WLTP-10-29e

33: Bag analysis close item

Background to OIL #33

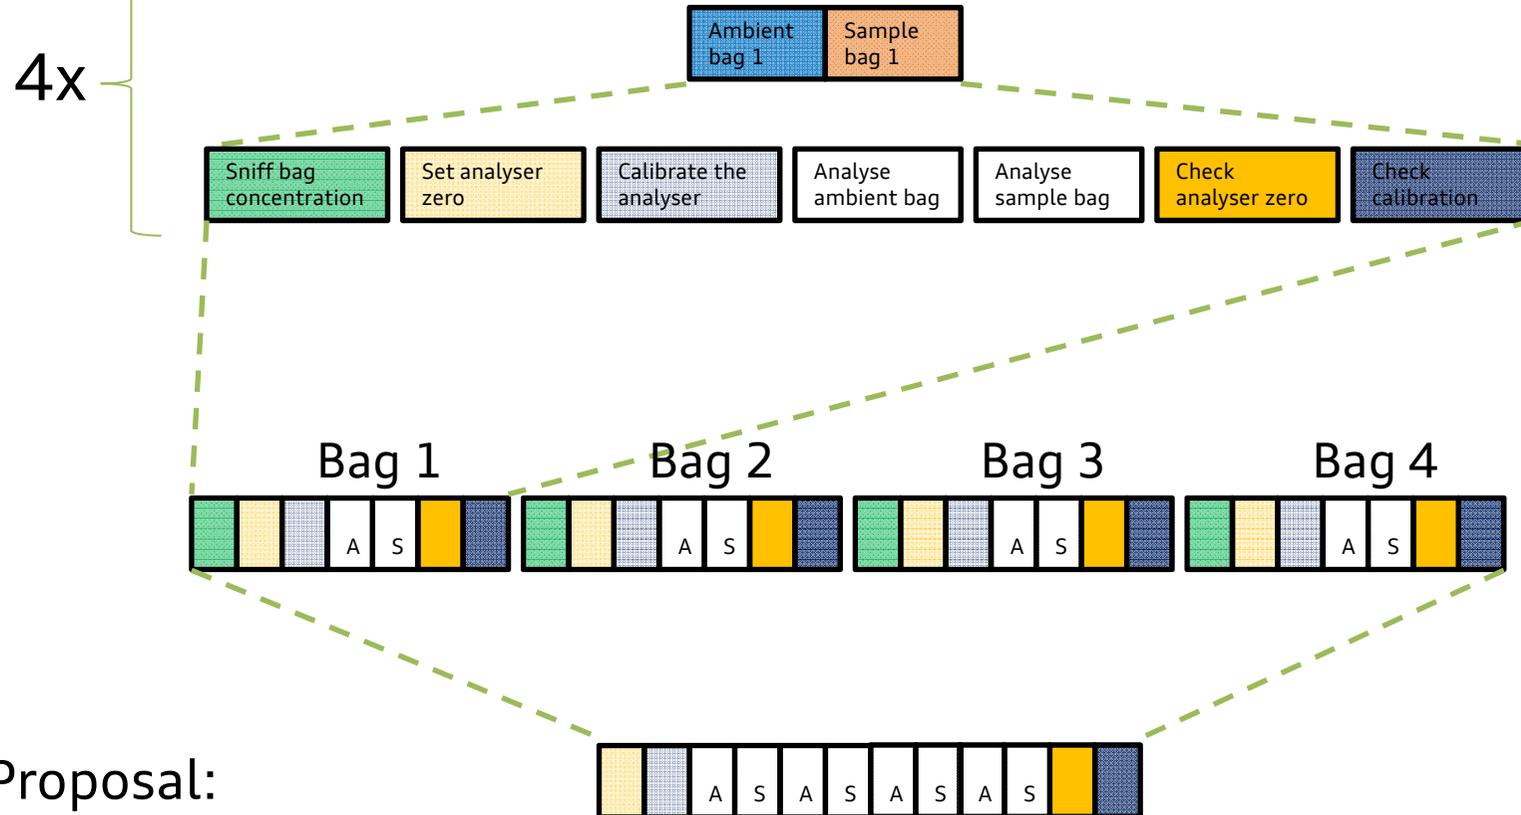
- ▶ **Background to open issue #33:**
 - ▶ Is analysis void more often due to the new process?
 - ▶ Is it possible to implement a drift correction if the 2 per cent difference are exceeded?

- ▶ The quality and stability of gas analysers has increased significantly within the last decades. Thus, it is not necessary to calibrate and recheck the analysers before and after each bag analysis, but only before the first bag and after the last bag, respectively.
 - ▶ Even after e.g. 30 min the deviation of the calibrated values and the check usually lie below 2 per cent.
- ▶ It is still allowed to perform recheck(s) between the initial calibration and the final recheck, if a lab has problems with analyser drift.
 - ▶ Early recheck could enable to perform re-calibration, re-reading, re-recheck within 30 min.
- ▶ For each bag measurement, there is an overlay of several uncertainties caused by:
 - ▶ Repeatability, noise of the analyser, Flush time of zero/calibration gas , drift, ...
- ▶ A correction method which works correctly for all cases is not available.

item #33 is withdrawn → close item
